CAMDEN CROSSING

PRELIMINARY SITE PLAN

City of Rochester Hills
Planning & Economic Development

Conditions and mark-ups noted throughout the plan set must be addressed prior to final approval.

M2J, LLC
CAMDEN CROSSING
PRELIMINARY SITE PLAN
FIRE PROTECTION PLAN

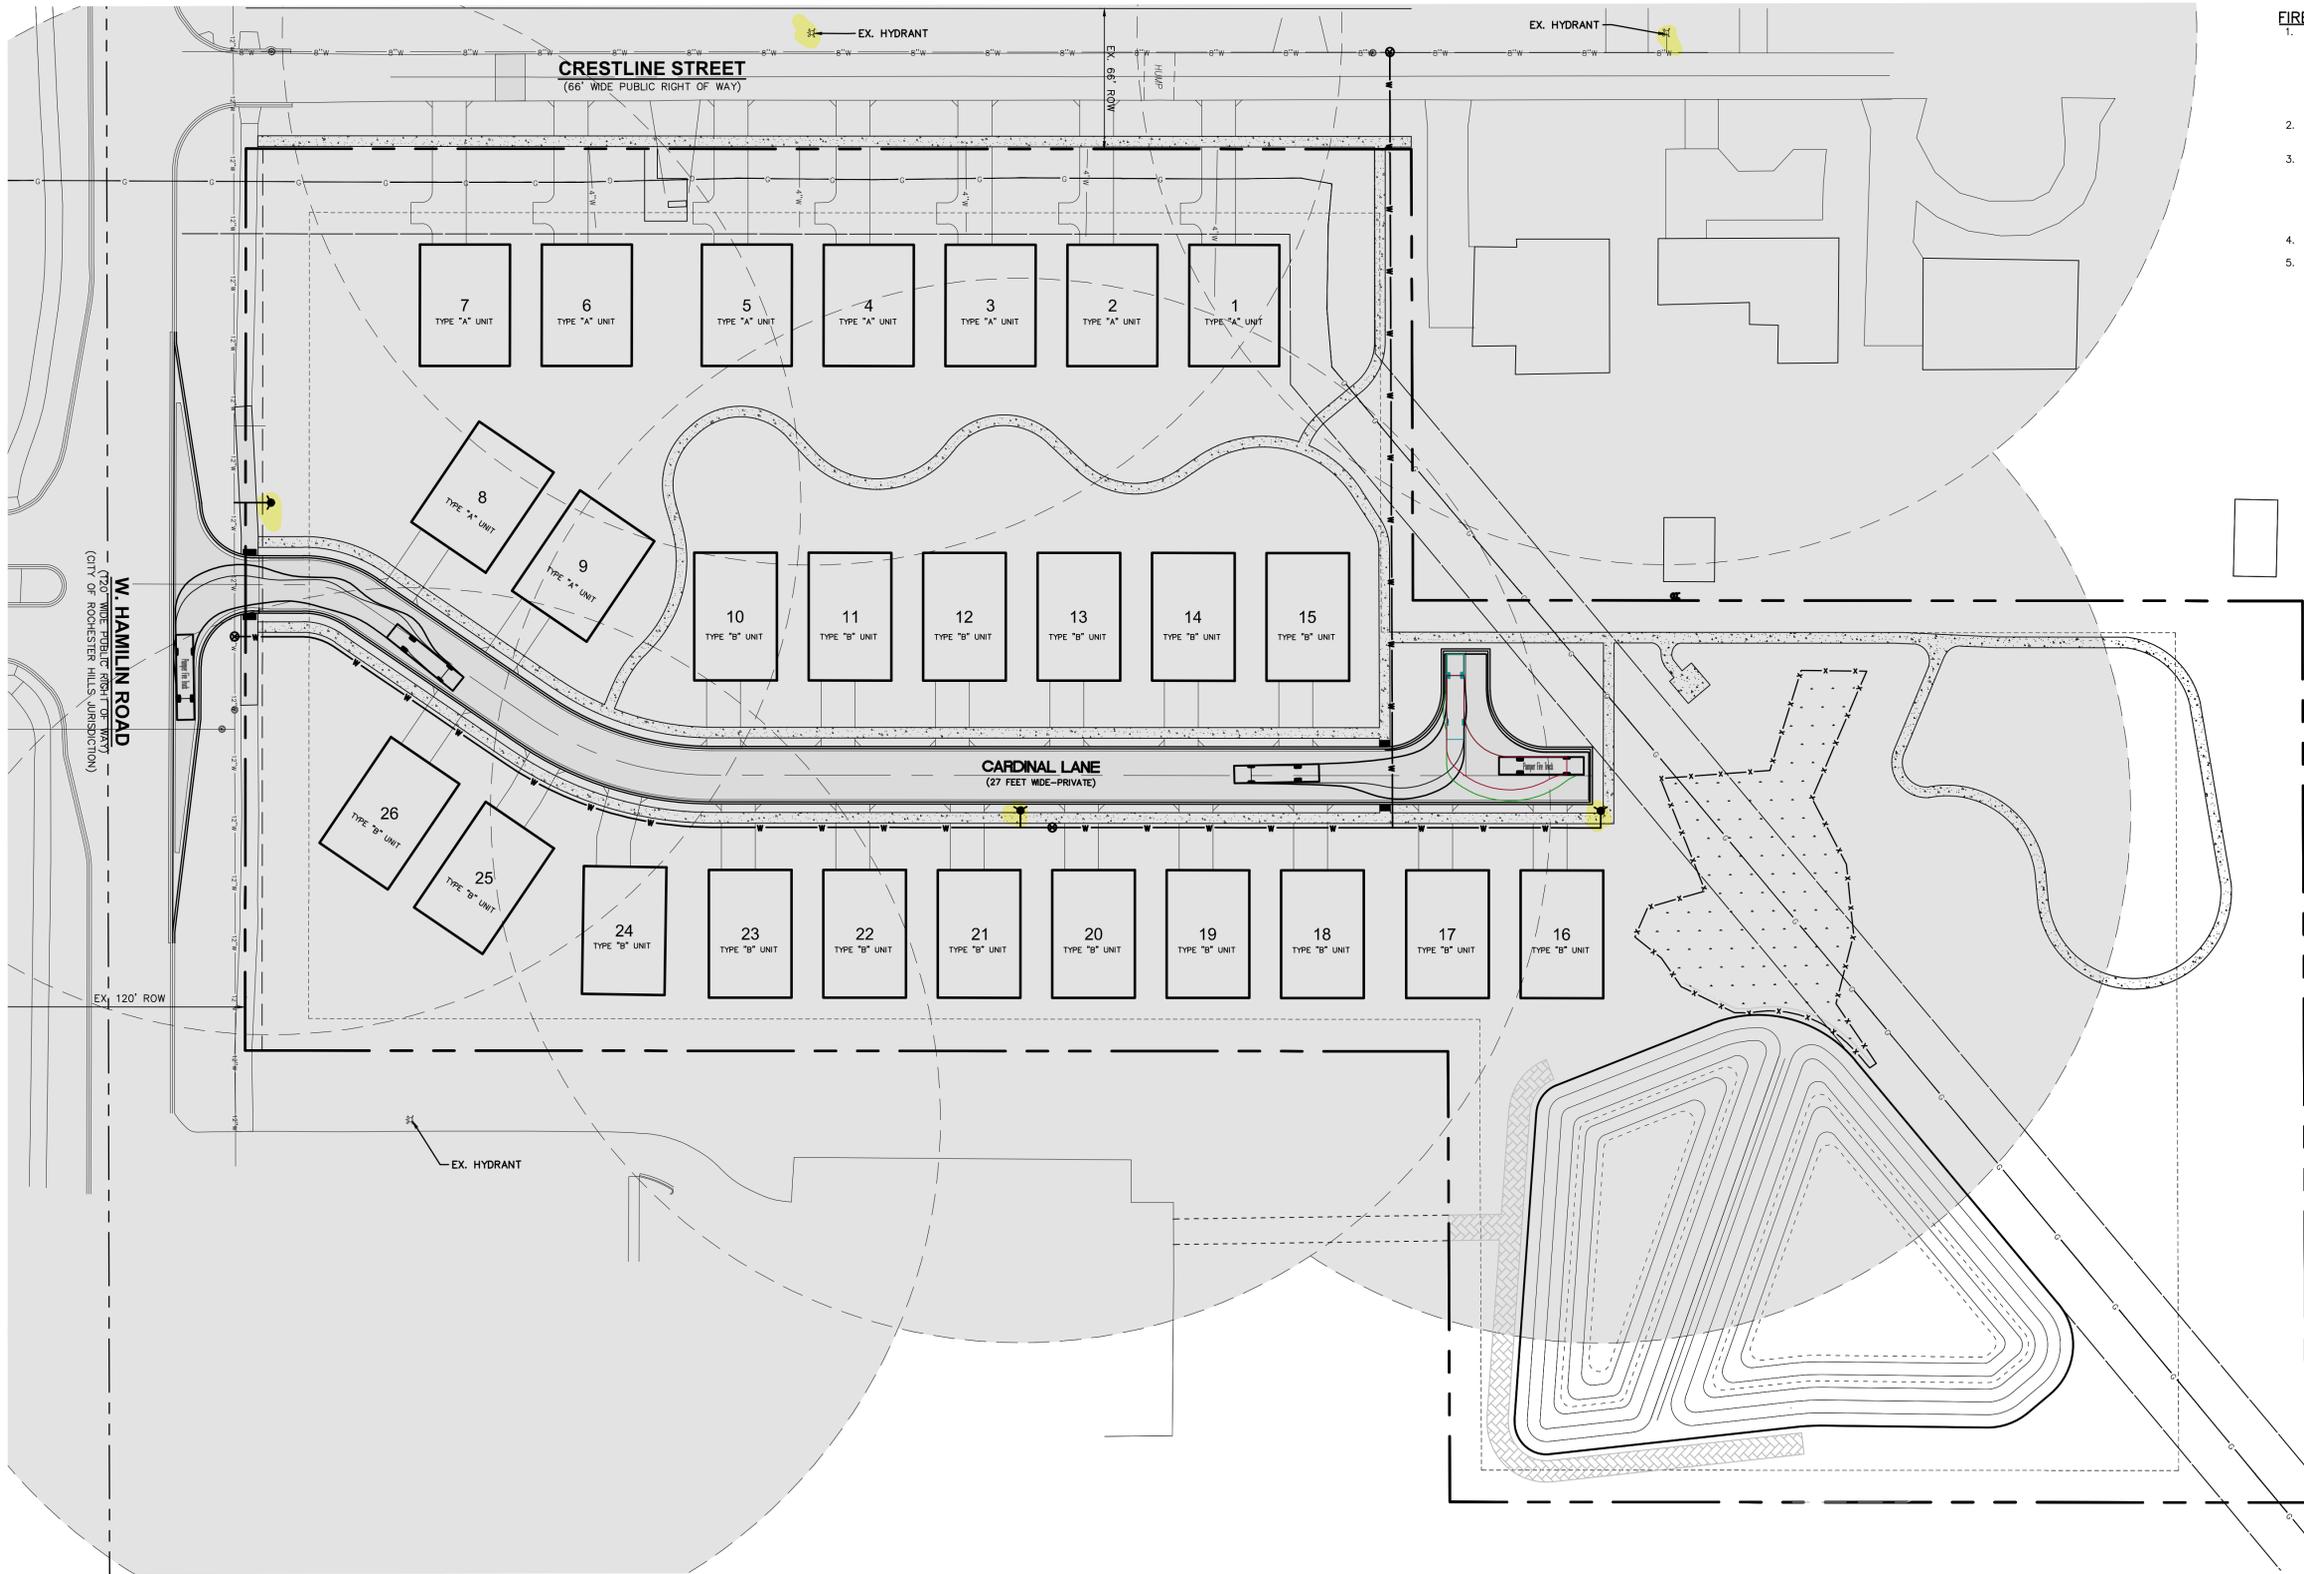
Construction type V with a maximum of 2,313 sq. ft. per house requires a fire flow of 1,000 GPM and an average fire hydrant spacing of 500 feet. Provide documentation, including calculations that a fire flow of 1,000 GPM can be provided. Flow test information can be obtained by contacting the Rochester Hills Engineering Department at 248-656-4640.
